NOTICE OF PROPOSED RESIDENTIAL HOUSING

Property: 26 Rose Crescent and 69-73 Bourke Street North Parramatta
Lots 2, 3 & 4 in DP 215342

SUB22/140977– Senior's Housing Development – 26 Rose Crescent and 69-73 Bourke Street North Parramatta

City of Parramatta Submission

- **Flood warning system for medium density**

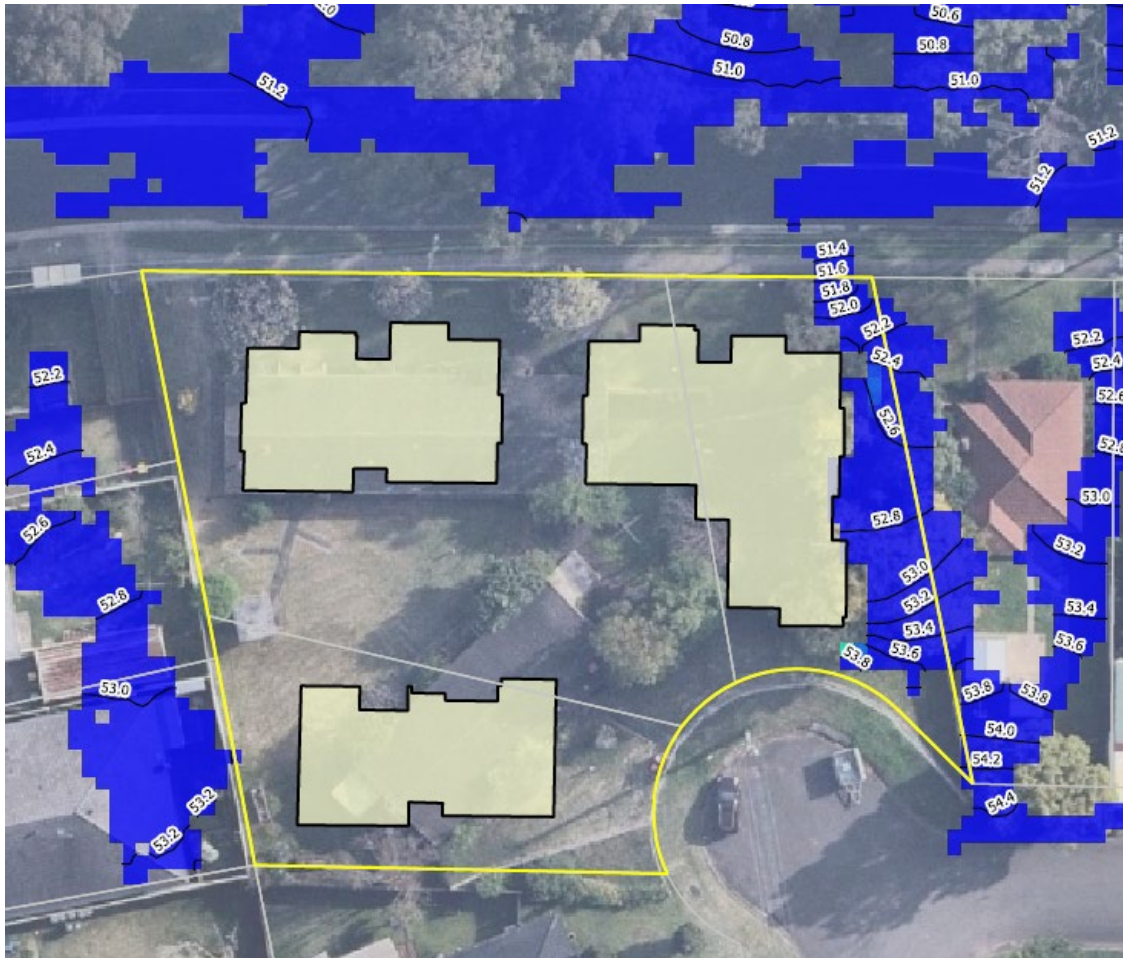
It was noted that the site is not impacted by the 1% AEP and therefore the warning alarm system would trigger during PMF events only. Council has recommended this condition to assist with risk mitigation for the proposed use.
